**ADDENDUM NO 1
TO
CONTRACT DOCUMENTS
FOR
Jordan Aqueduct, Reach 4 Blow-Off Drain

DISTRICT PROJECT NO.: 4232

08/29/2025**

TRENCH DETAILS

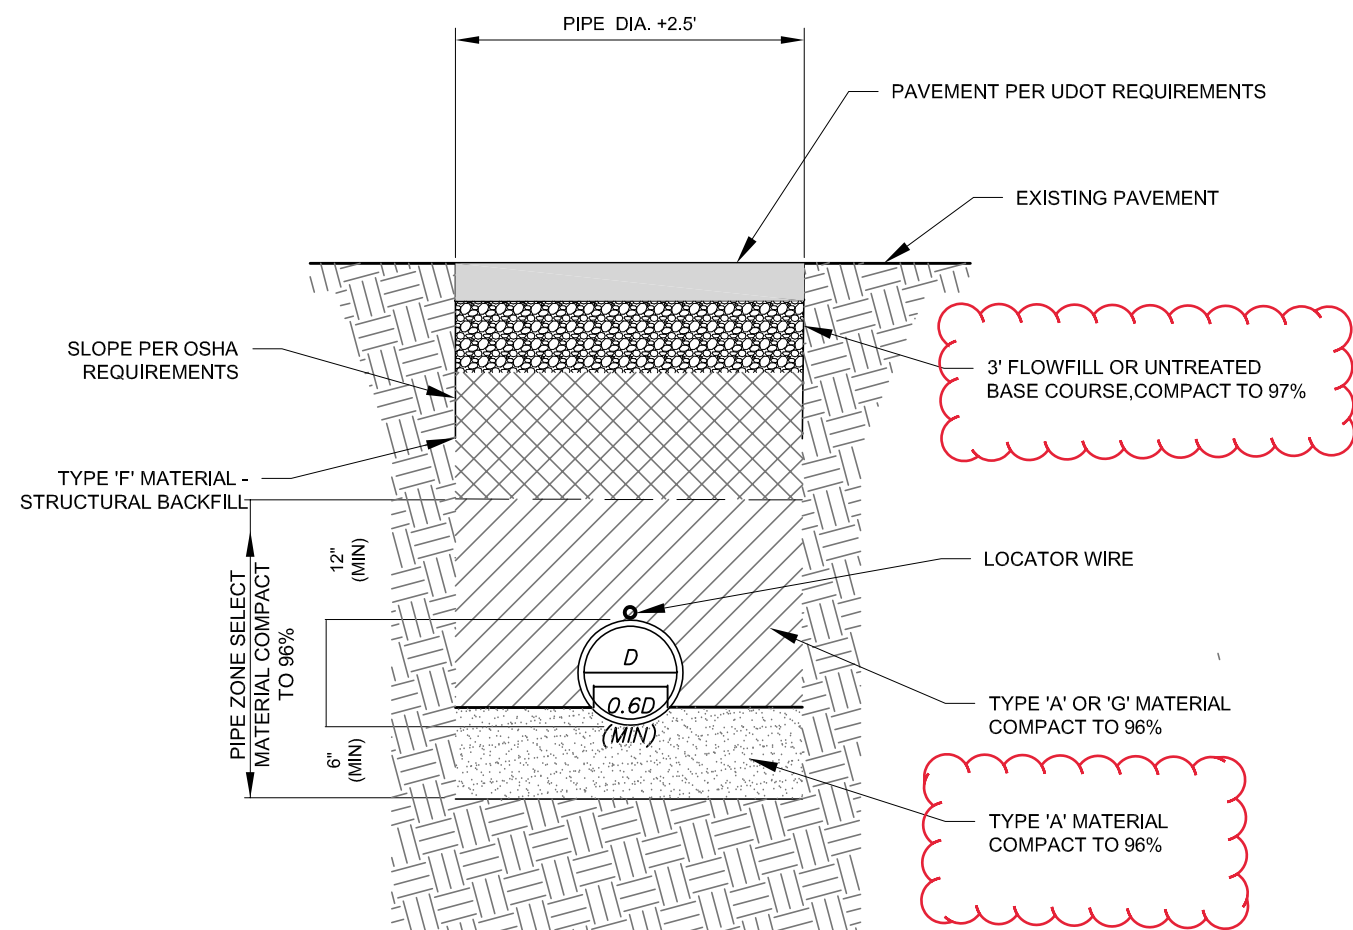
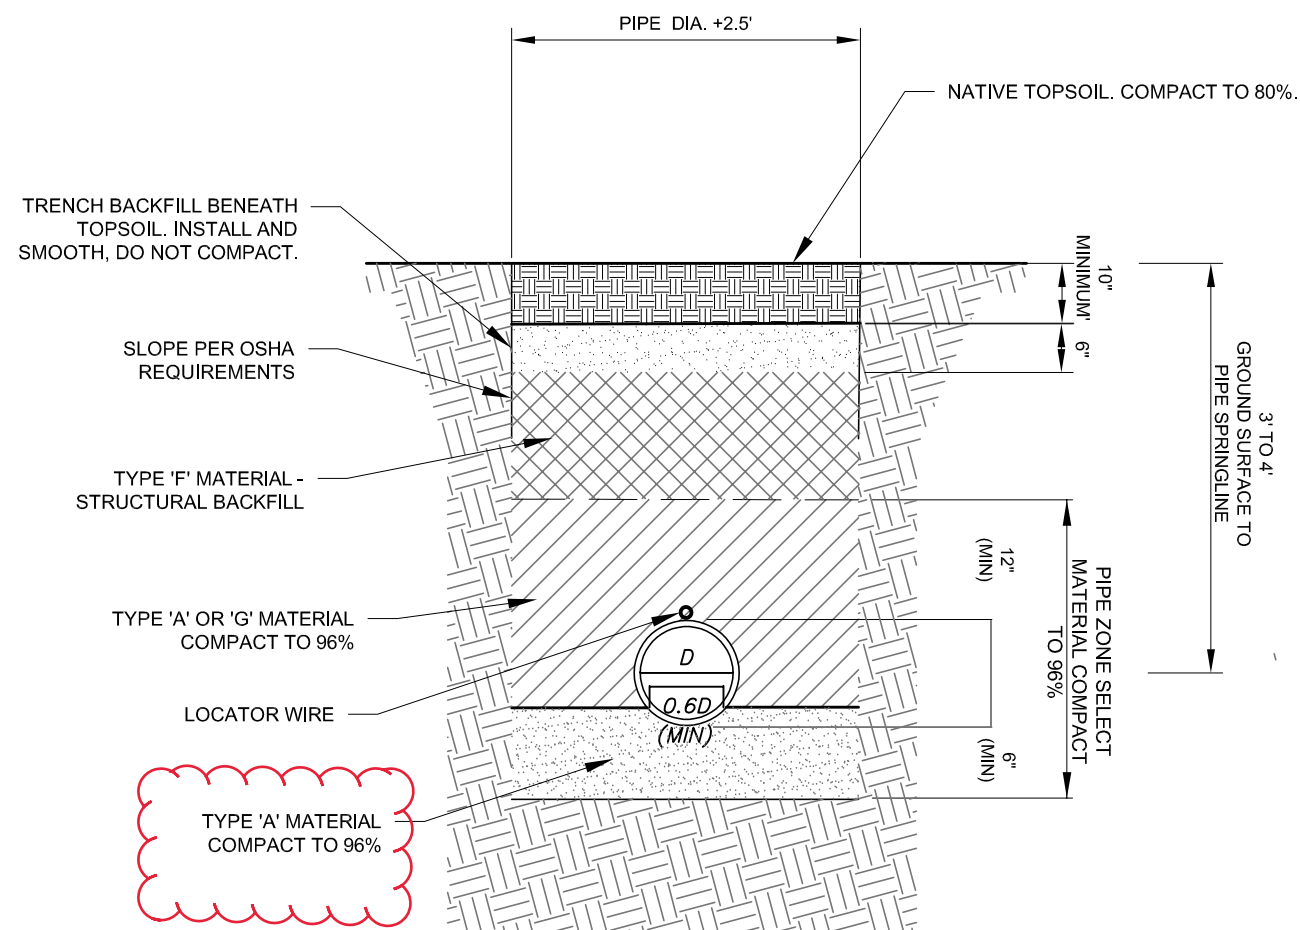
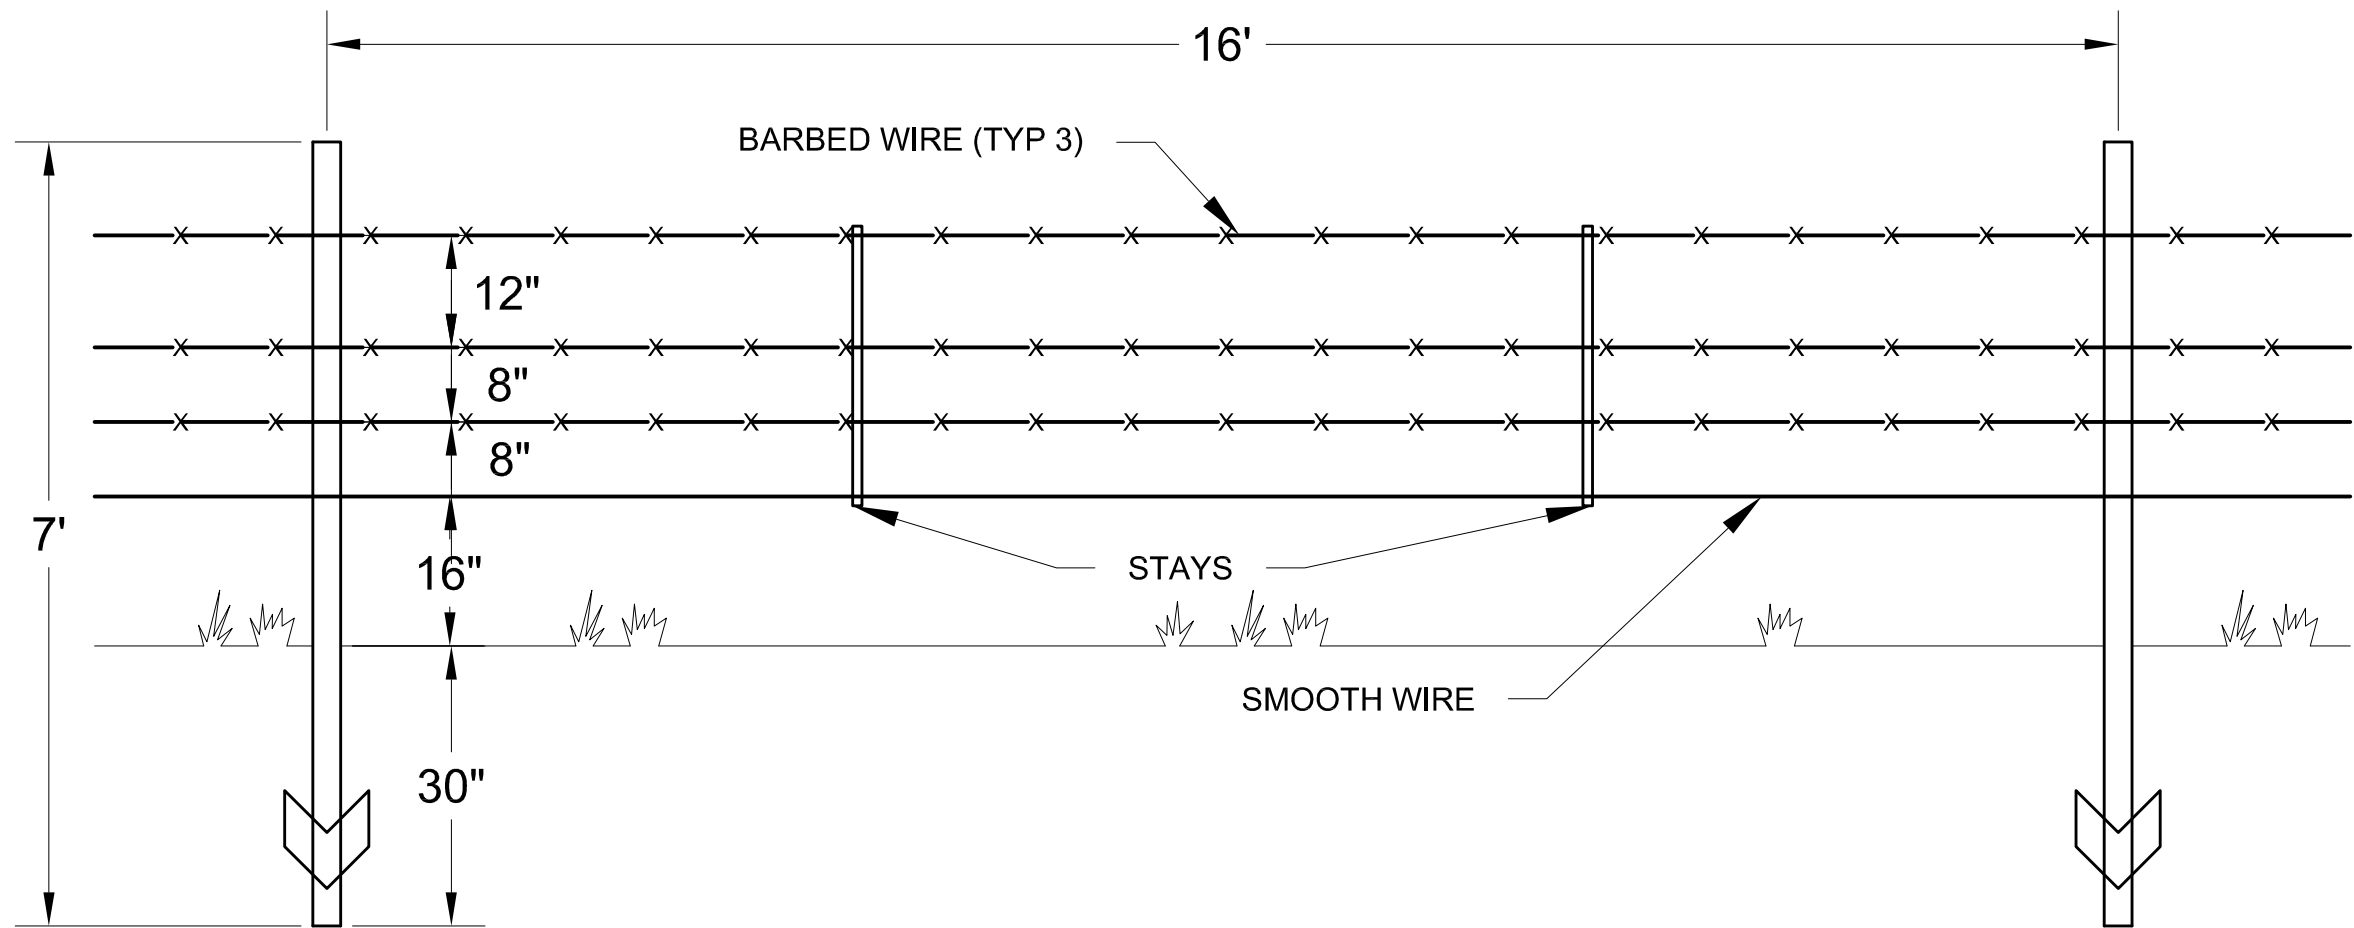
C PIPE TRENCH UNDER ROAD SECTION
SCALE: NTS
NOTE: UDOT REQUIRES 2" MILL AND OVERLAY, 10' ON EACH SIDE OF TRENCH

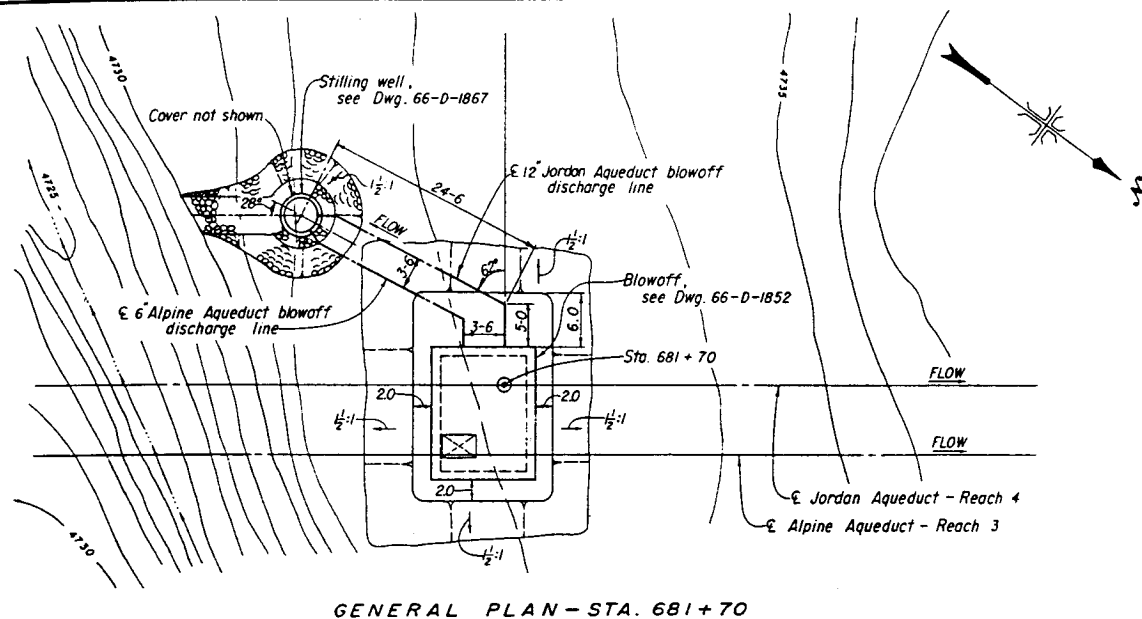
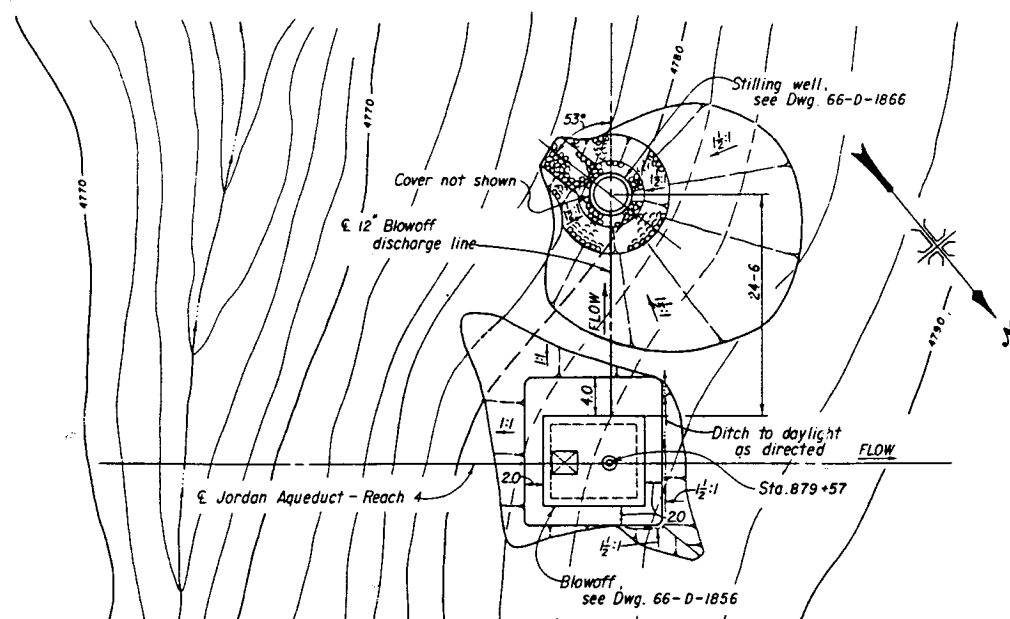
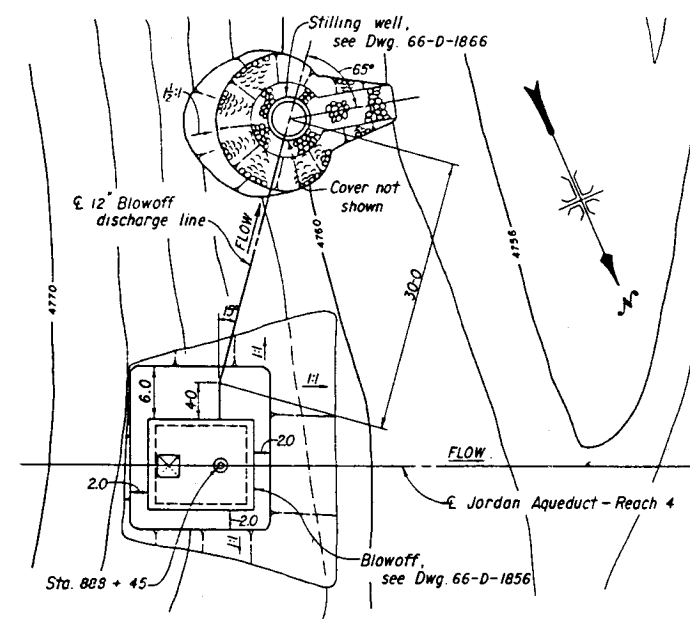
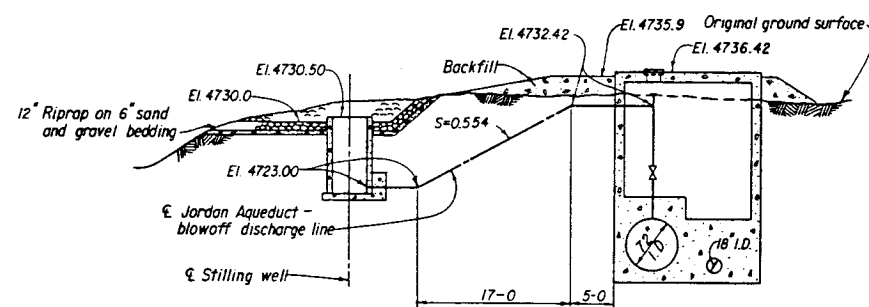
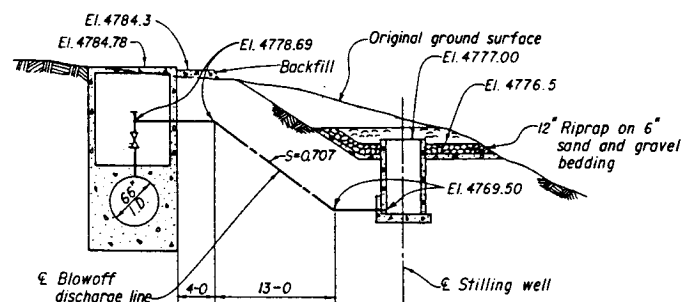
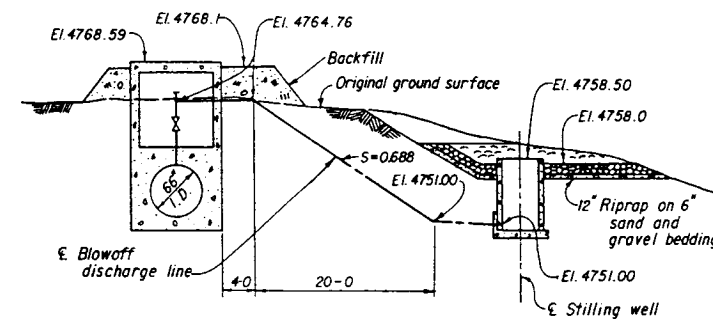
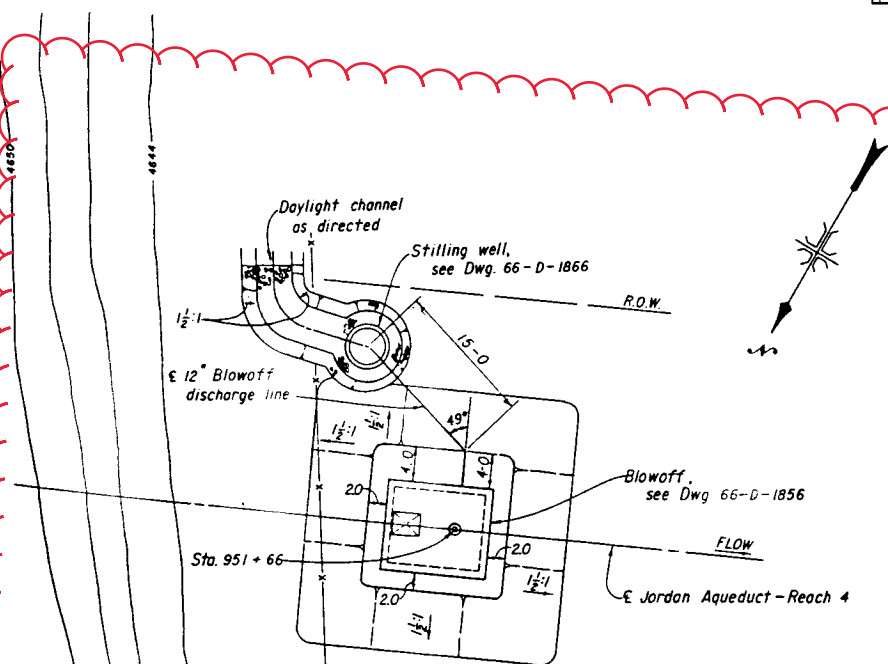
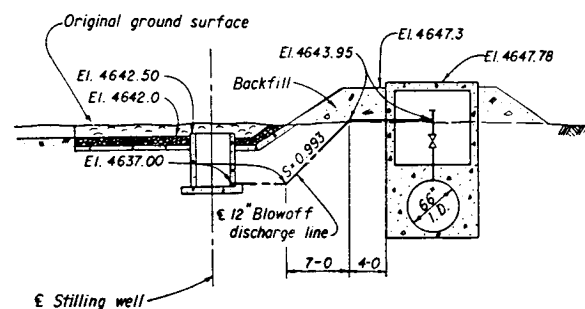
What is the size of the stilling basin to be removed and filled with gravel?

Two drawings from the original aqueduct drawings, showing the designs for the still basin are included with this addendum
